1.14 Existing Door and Architrave Schedule

Conservation Officer Comment

Existing Basement Plan - Door Schedule

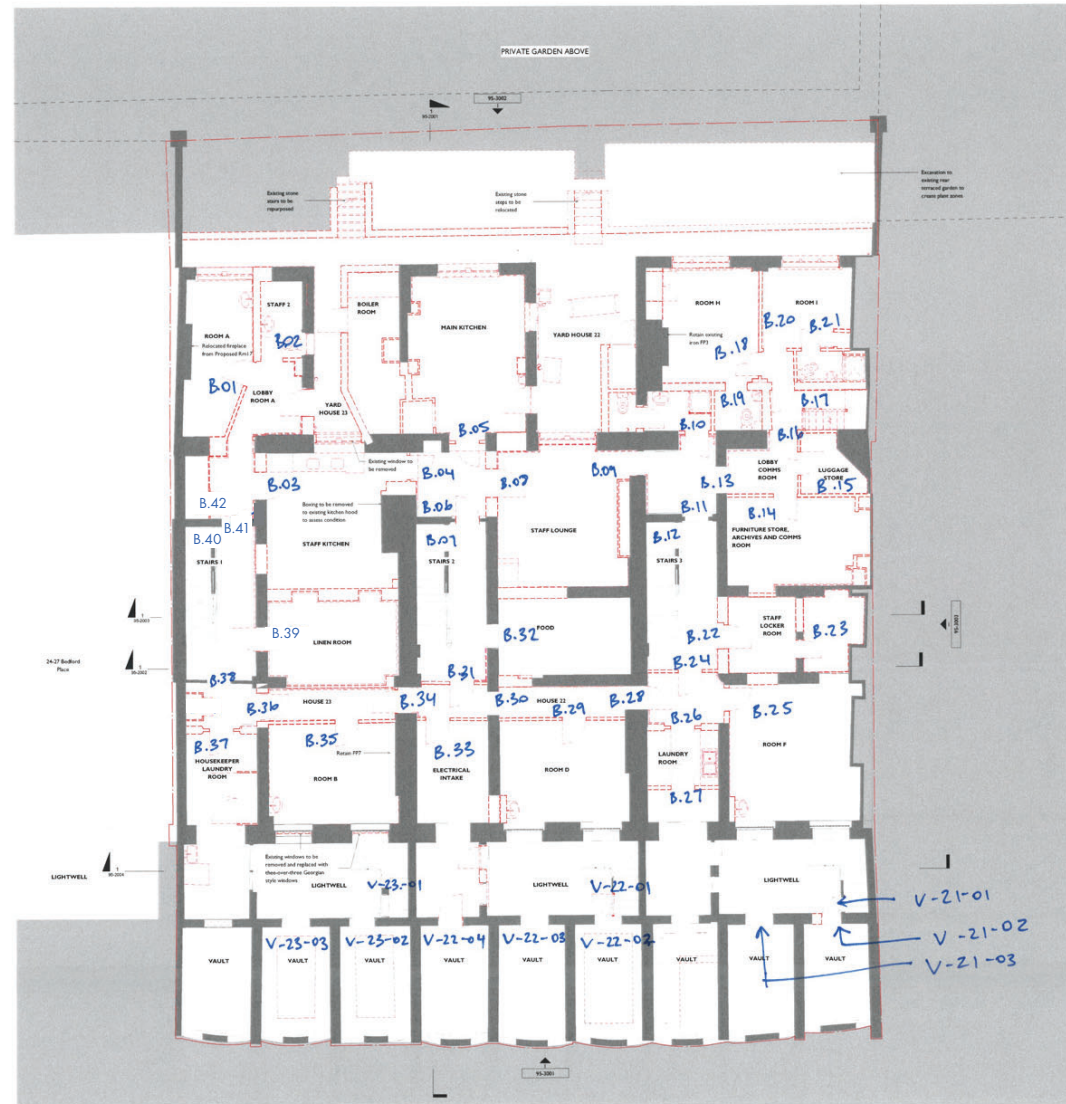
A schedule/key should be provided regarding the treatment of each of the historic doors and associated architraves etc. Where doors are no longer required (but the wall is retained), the preference would be to have them fixed closed with no gib added so that they remain legible features. Where doors/architraves "must" be moved to rearrange the floor plan, these units should be reused (in a historically appropriate location) within the building.

Please see door schedule which catalogues all existing doors. We have sought to retain all original doors. A few doors appear to have some age but most, if not all of these, have been backed with modern flat panels to provide the necessary fire rating.

Given the high quality nature of the proposed hotel we are not in a position to retain these doors. We would prefer to replace these in a scholarly manner, with panels to both sides to match the original doors (on each floor), which provide an appropriate fire rating. At present many of the doors do not meet the required fire and acoustic ratings and are too thin to be adapted for the modern day keyless door controls. We would like to agree with officers on the approach of retention / removal of the existing doors prior to providing details of the new doors.

Our intention would be to provide corresponding proposed doors and architraves in due course. Any new doors would respond to the hierarchy of each floor. The intention would be to have simple four panelled doors without moulding details to the Basement and Level 03; four panelled doors with simple moulding detail to the panels to Level 02 and four panelled doors with more elaborate moulding detail to the panels as well as an inner bead detail to the panels at Ground and Level 01.
